SUBJECT: NEW ORCHARD FARM ELEMENTARY SCHOOL
ORCHARD FARM R-V SCHOOL DISTRICT
ST. CHARLES, MISSOURI
PROJECT # 23-09B

ADDENDUM NO. 1 PROJECT 23-09B
ORCHARD FARM R-V SCHOOL DISTRICT
NEW ELEMENTARY SCHOOL
ST. CHARLES, MISSOURI JULY 23, 2024

The drawings and specifications are hereby supplemented and amended to include the following particulars:

SHEET NO.
E3.2
SD: 22

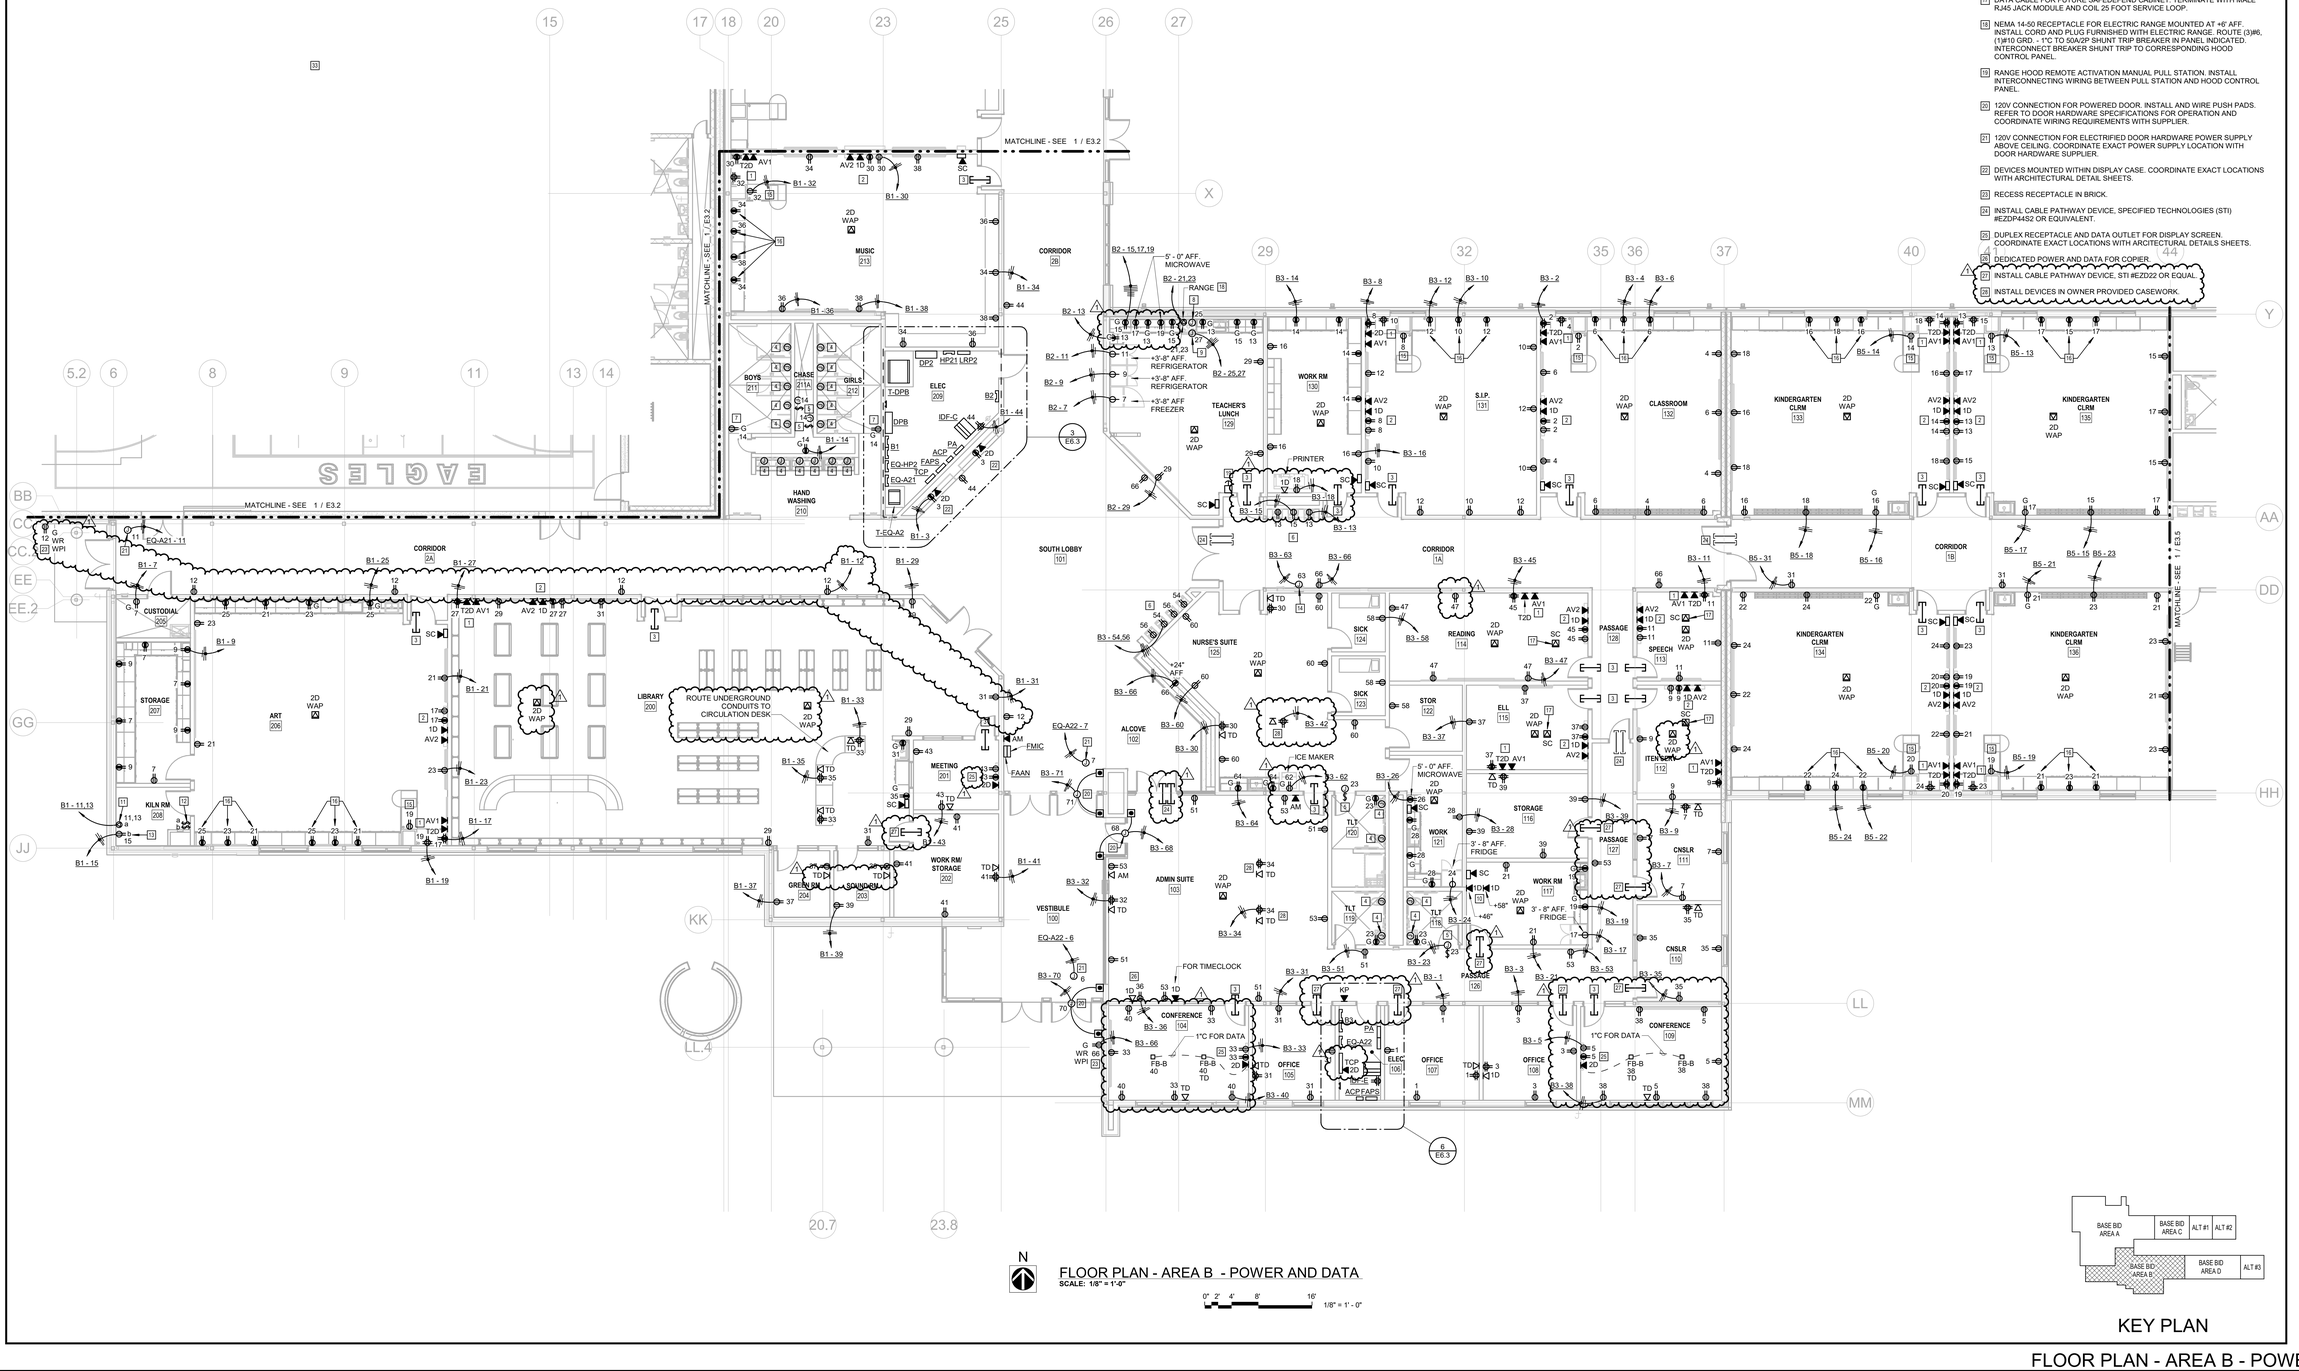
A. **"ADD"** Fire alarm power supply and circuit.
B. **"ADD"** Temperature control panel with circuit and 2D.
C. **"CHANGE"** Exterior receptacle outside of Vestibule 322 circuit.
D. **"ADD"** Keyed note 3 and conduit sleeve into DZ Office/Reception 321.
E. **"ADD"** Keyed note 3 and conduit sleeve into Sensory 215.
F. **"ADD"** Keyed note 33.
G. **"CLARIFICATION"** Stub up location to floor boxes in Gymnasium.
H. **"ADD"** Note to Sound 221.
I. **"REVISE"** Location of keyed note 3 and conduit sleeve in Room 303.
J. **"ADD"** Keyed note 3 and conduit sleeve into Storage 302.
K. **"CHANGE"** Keyed note on exterior receptacle outside of Vestibule 401.
L. **"ADD"** Keyed note 3 and conduit sleeve into OT/PT 301.
M. **"CHANGE"** Circuit for receptacles near Corridor 4A.
N. **"ADD"** Circuit homeruns.

PROJ. NO.	23-09B
DATE ISSUED	07-02-2024
1 DATE REVISION	07-23-24 ADDENDUM #1
DRAWN BY	NAM
CHECKED BY	JMW
SHEET NO.	E5.2
	SD: 25

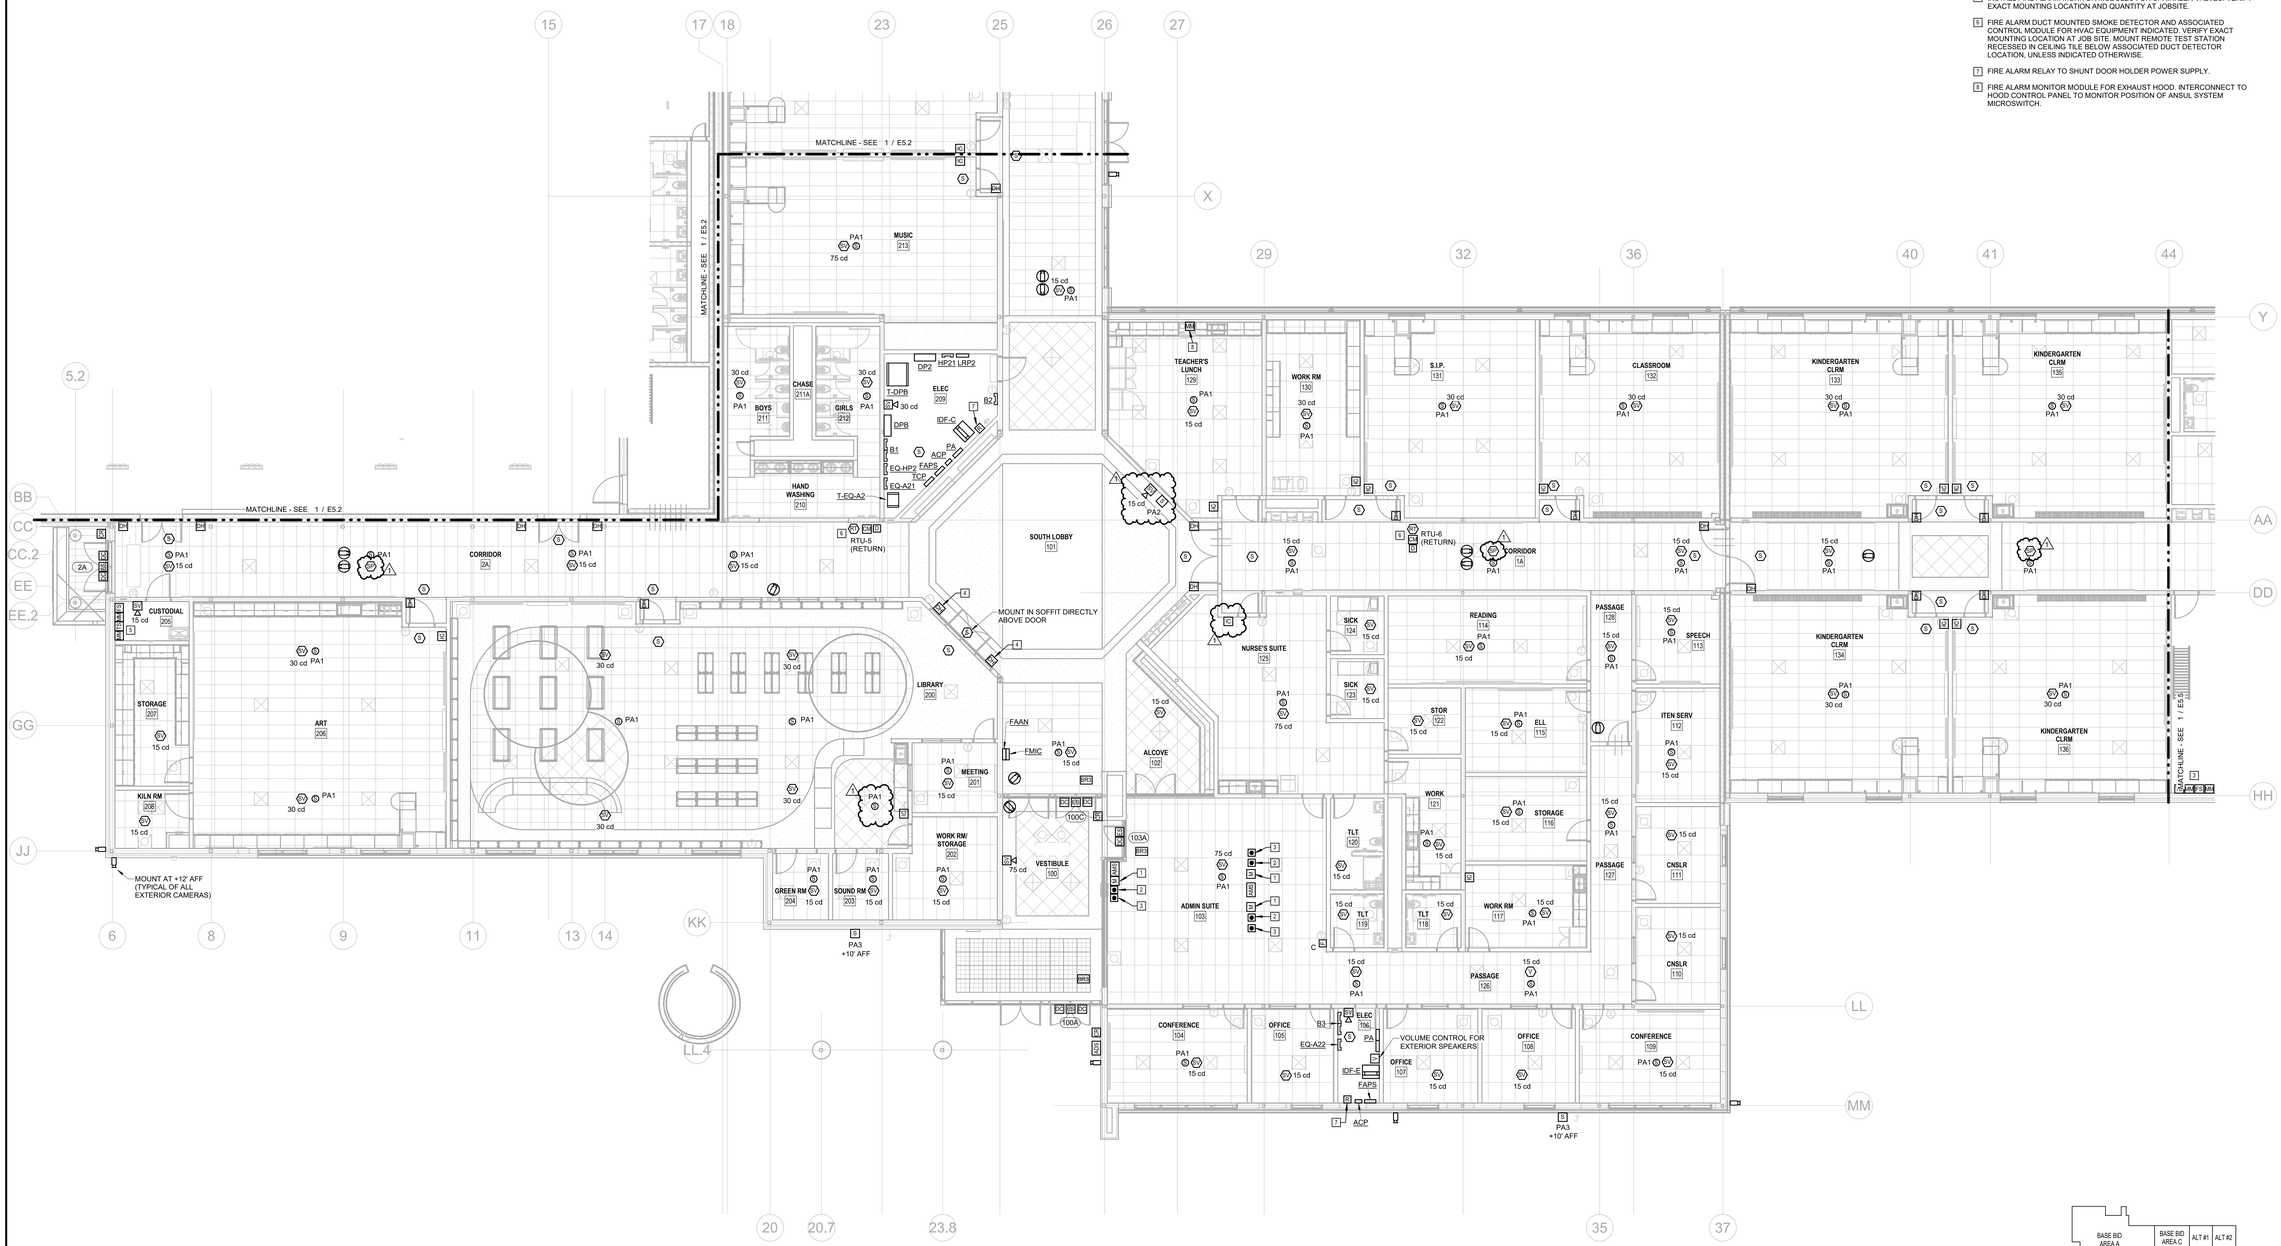
A. **"ADD"** Fire alarm power supply and smoke detector on mezzanine.
B. **"CHANGE"** Location of intercom in DZ Office/Reception 321.
C. **"ADD"** Keyed note 11.
D. **"ADD"** Fire alarm speaker/strobe in walk-in cooler/freezer.
E. **"ADD"** Keyed note 2 to carbon monoxide detector in Serving 315.
F. **"ADD"** Fire alarm speaker/strobe in Passage 313.
G. **"DELETE"** Intercom button in Passage 313.
H. **"ADD"** PA1 speaker in Chair Storage 308.
I. **"ADD"** Keyed note 1 to speaker in gym.
J. **"ADD"** PA4 speaker in PE Storage 223.
K. **"CHANGE"** Location of fire alarm speaker/strobe to PE Storage 223.
L. **"ADD"** PA1 speaker and fire alarm speaker/strobe in Corridor 2B.
M. **"CHANGE"** (3) fire alarm strobe only devices to (3) fire alarm speaker only devices in corridor.

PROJ. NO.	23-09B
DATE ISSUED	07-02-2024
⚠ DATE REVISION	1 07-23-24 ADDENDUM #1
DRAWN BY	NAM
CHECKED BY	JMW
SHEET NO.	E5.3
	SD: 26

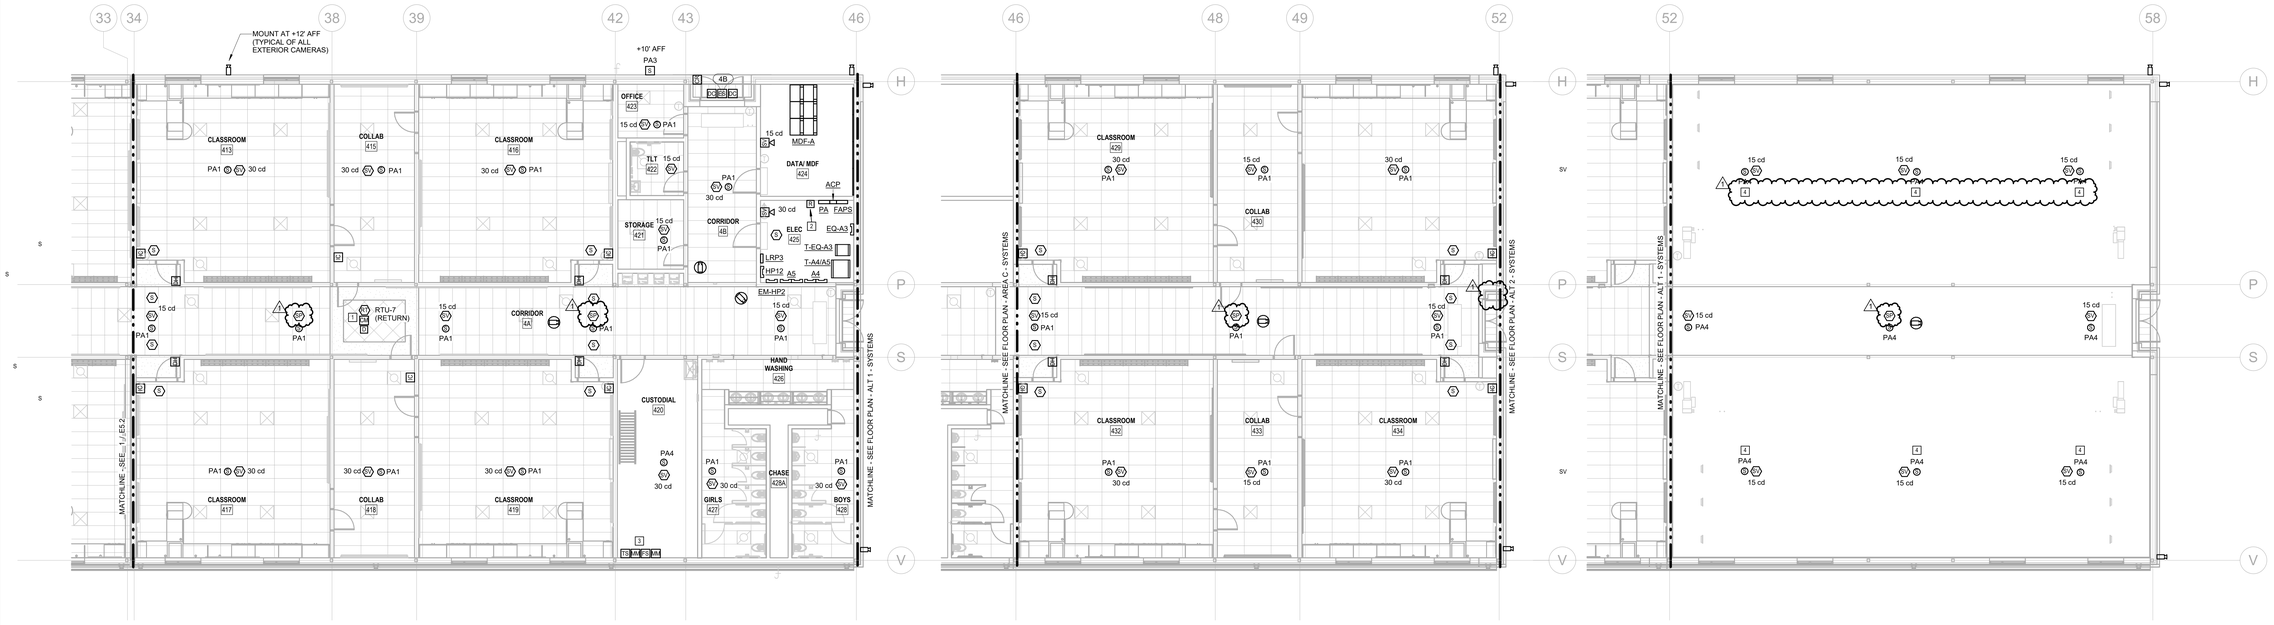
A. **"CHANGE"** (3) fire alarm strobe only devices to (3) fire alarm speaker only devices in corridor.
B. **"ADD"** PA1 speaker in Library 200.
C. **"ADD"** PA2 speaker and fire alarm speaker/strobe in South Lobby 101.
D. **"ADD"** Intercom button in Nurse's Suite 125.

E5.4
SD: 27

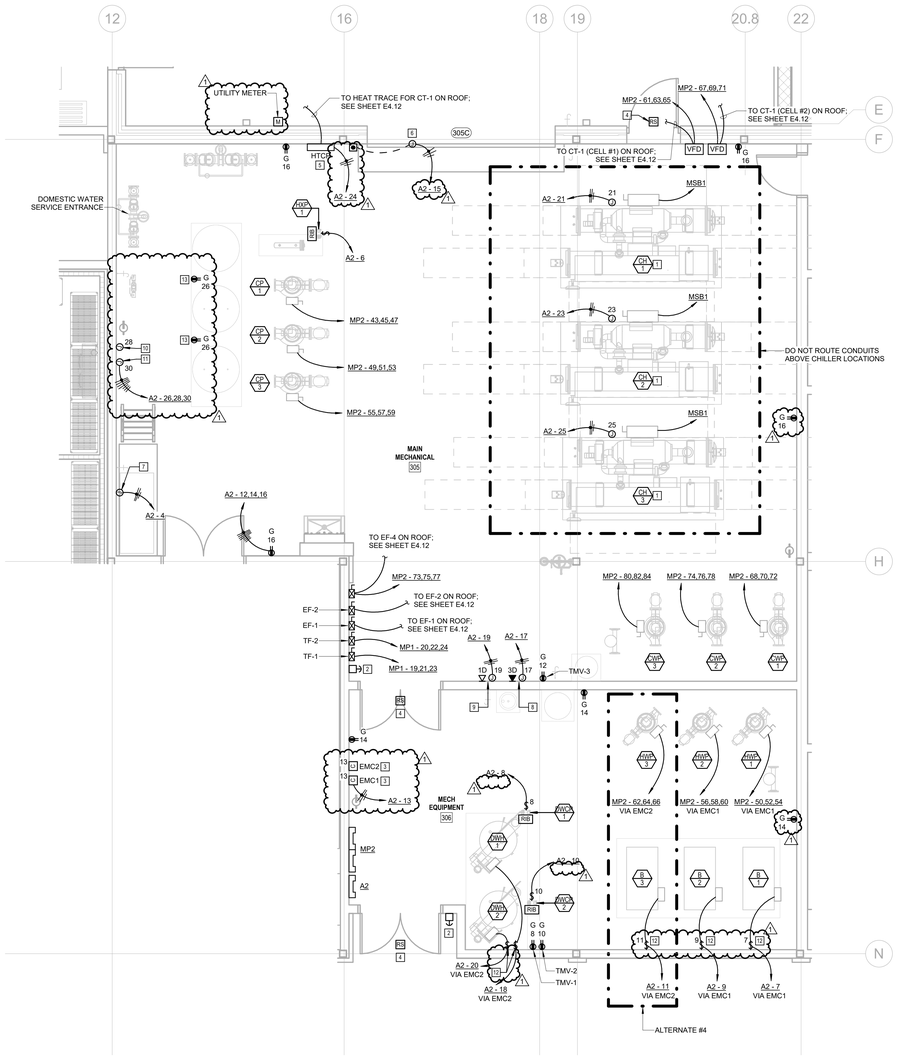
A. **"ADD"** Smoke detector in Elec 425.
B. **"DELETE"** Card reader on Alt #1 exterior door.
C. **"ADD"** Keyed note 4 to speakers in north half of Alt #2.
D. **"CHANGE"** (4) fire alarm strobe only devices to (4) fire alarm speaker only devices in corridor.

E6.2
SD: 28

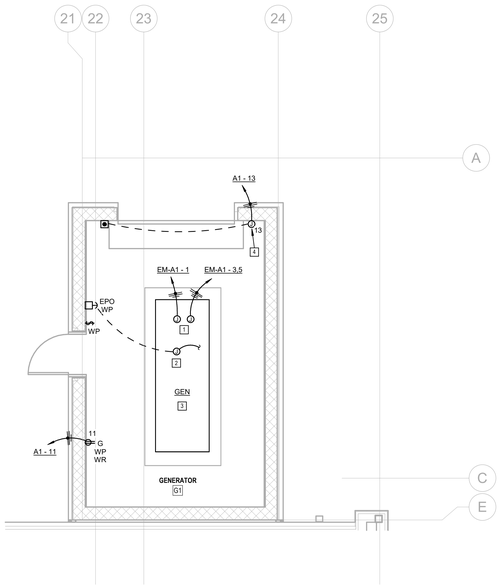
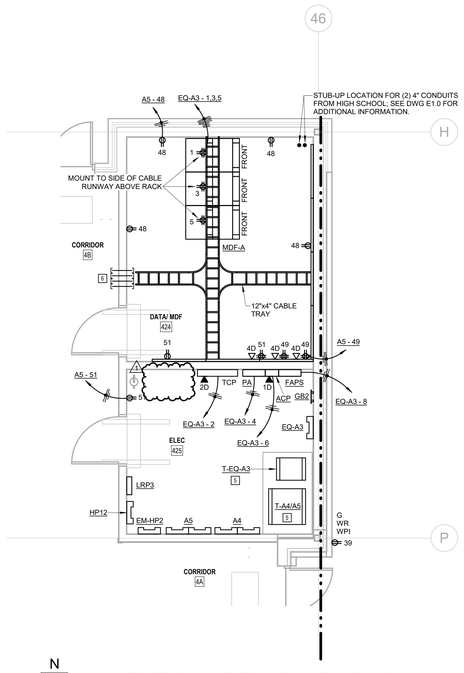
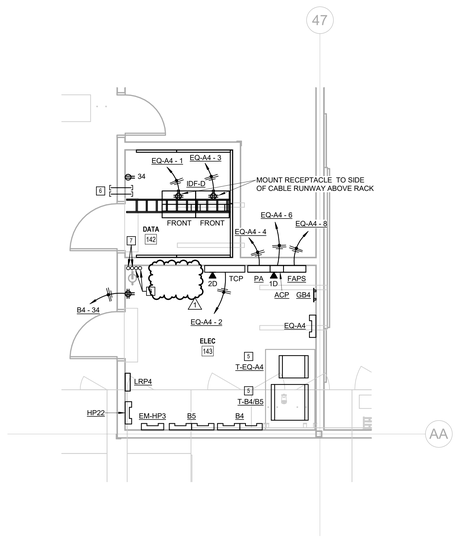
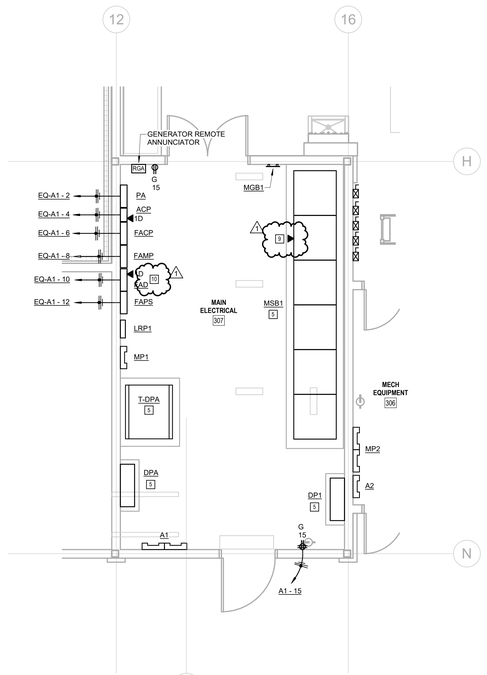
A. **"ADD"** Junction boxes and circuit for power make-up water meter and blowdown solenoid valve.
B. **"ADD"** Keyed note 10, 11, and 12.
C. **"ADD"** GFCI receptacles for water softeners and note.
D. **"ADD"** Utility meter.
E. **"ADD"** Circuit to HTCP.
F. **"CHANGE"** Circuit for overhead coiling door motor.
G. **"ADD"** GFCI receptacle on east wall in Main Mechanical 305.
H. **"ADD"** GFCI receptacle on east wall in Mech Equipment 306.
I. **"CHANGE"** Feed EMC1 and EMC2 from the same circuit.
J. **"CHANGE"** Circuit to DWCP-1 and DWCP-2.
K. **"CHANGE"** Boiler disconnects to toggle switches.
L. **"ADD"** Refrigerant alarm strobe outside south doors to Main Mechanical 305.
